Re: DART+ West Railway Order - Dublin City to Maynooth and M3 Parkway
County Dublin, County Meath, County Kildare

Re: DART + West Railway Order – Dublin City to Maynooth and M3 Parkway
Our Client: Carlos Clarke Limited
Case Number: ABP-314232-22

Callan Tansey Limited Submission on behalf of Carlos Clarke Limited in relation to the Update to the Natura Impact Statement. NA29S.314232

Re Section "4 HYDROLOGICAL EFFECTS ON THE RYE WATER VALLEY/CARTON SAC

Drainage Details at Maws Farm and Environs

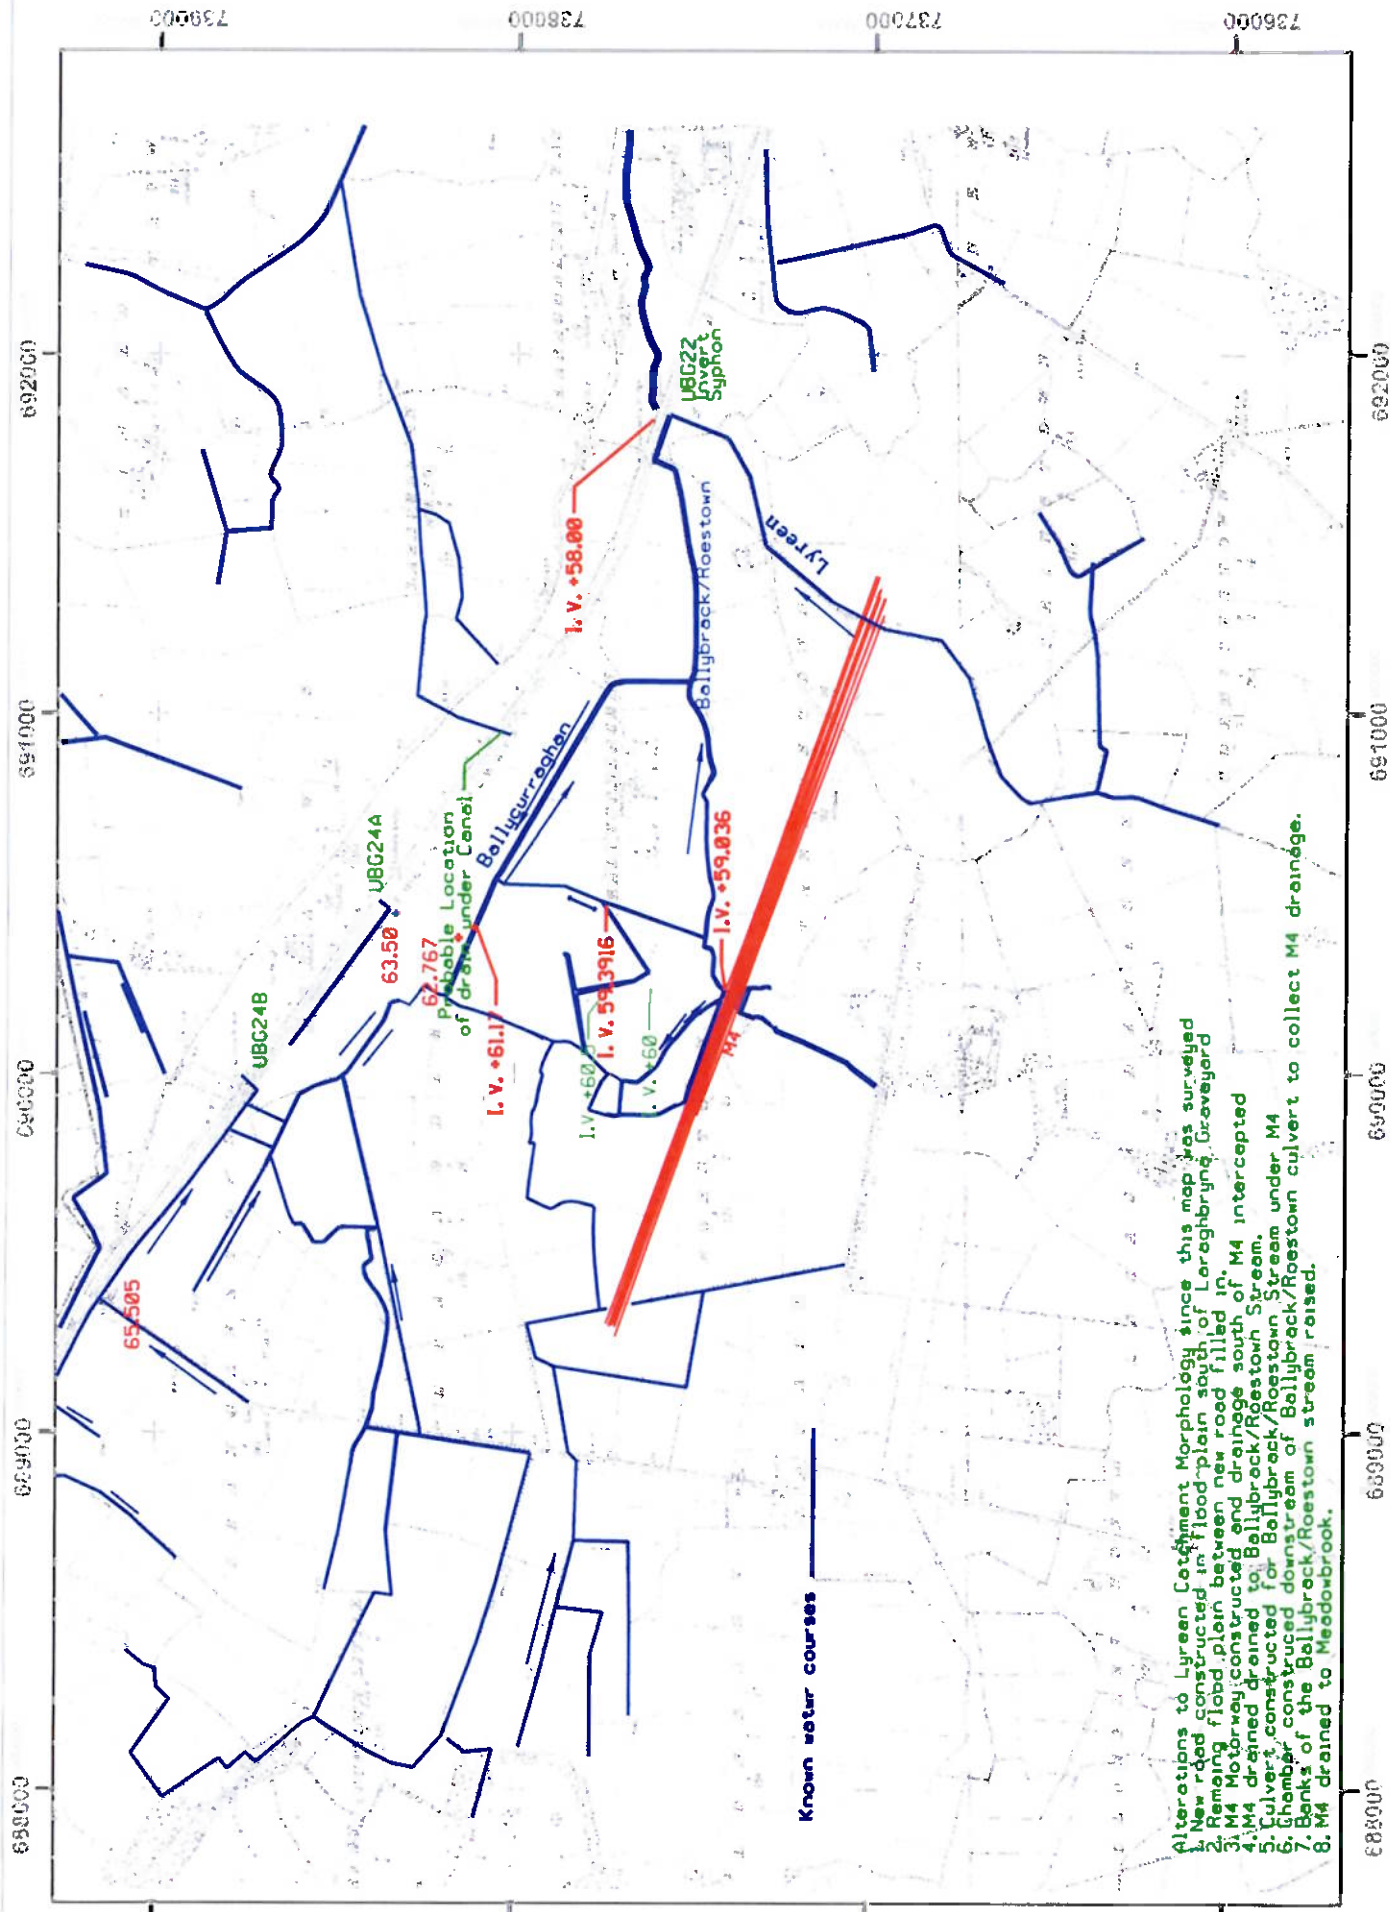
- Alterations to Lureen Catchment Morphology since this map was surveyed
1. New road constructed in flood-plain south of Laraghbrin, Graveyard
 2. Raising flood-plain between new road filled in.
 3. M4 Motorway constructed and drainage south of M4 intercepted
 4. M4 drained to culvert south of Ballybrock/Roestown Stream.
 5. Culvert constructed for Ballybrock/Roestown Stream under M4
 6. Chamber constructed downstream of Ballybrock/Roestown stream
 7. Banks of the Ballybrock/Roestown stream raised.
 8. M4 drained to Meadorbrook.

Figure 5-3 Subject Catchments for Hydrological Assessment at Depot / Jackson's Bridge

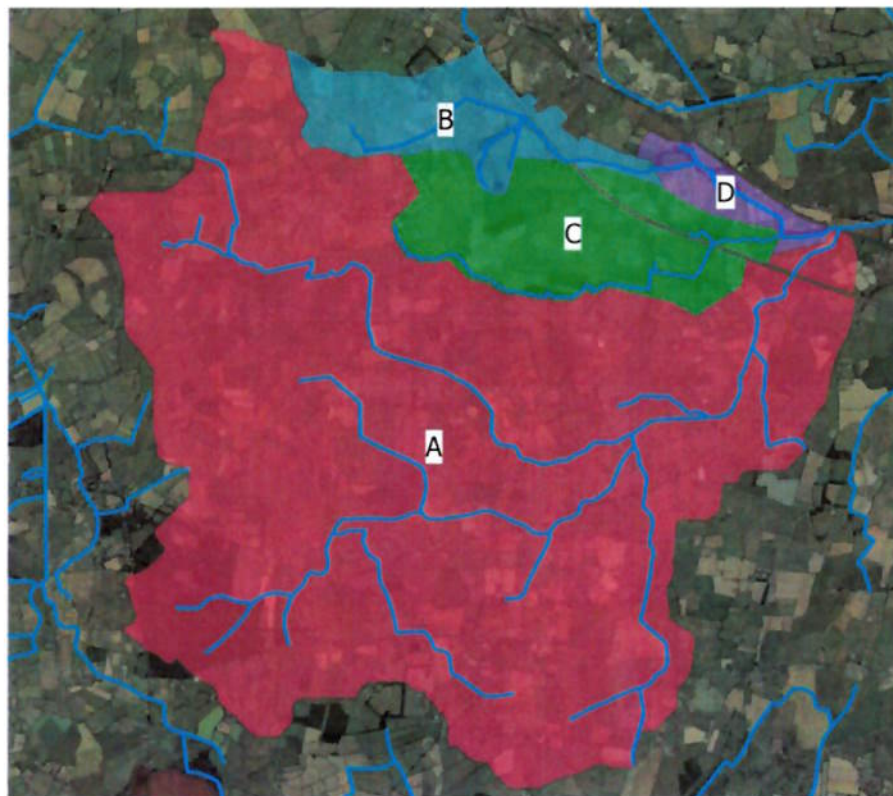
The four locations are not shown in Fig 5-3. The purpose of Site Specific Flood Risk Analysis is to analysis the flooding at the site before and after the proposed development. The existing flooding is caused by joint inter action of the backing up from the weir on the Lyreen, the infilling of the flood plain upstream of the weir and consequential raise in level a the outlet of the submerged syphon UDG22. the pressure loss through the syphon. These factors don't appear to be included in the analysis. The catchment area of the four sub-catchments upstream of UBG22 is 62.68 sq. km whereas the actual catchment area is 72 sq. km.
